Regulations Nos. 13 and 13-H (Braking) - Clarifications

Proposal for amendments to Regulation No. 13 (Heavy vehicle braking)

Submitted by the experts from the European Association of Automotive Suppliers *

"FIGURE 1A

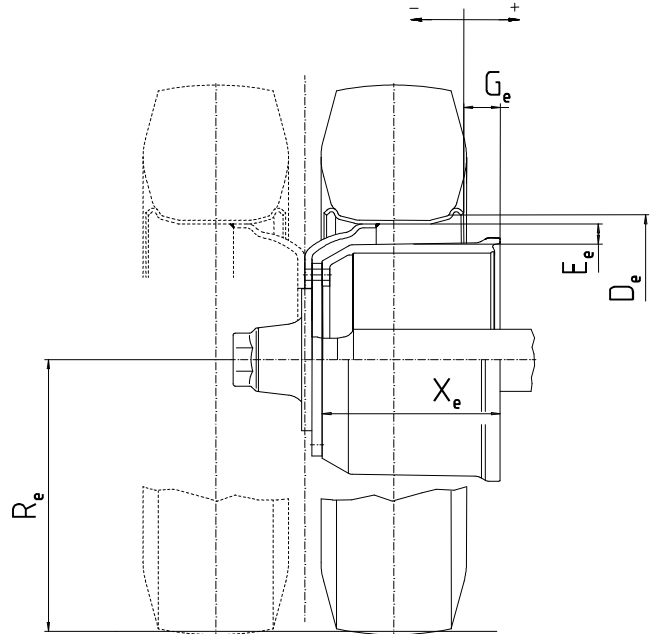
Annex 11, Appendix 5, Figure 1A, amend to read:

1. To be in line with Figure 1B and with the letter D as a diameter it is proposed to correct the drawing.
2. The current Figure 1A incorrectly shows D as the radius of the wheel:

In moving the Figures 1A, 1B, 2A and 2B from Appendix 3 to Appendix 5 as part of Supplement 2 to the 11 Series of Amendments, the dimension D_e in Figure 1A was changed from a diameter to a radius.
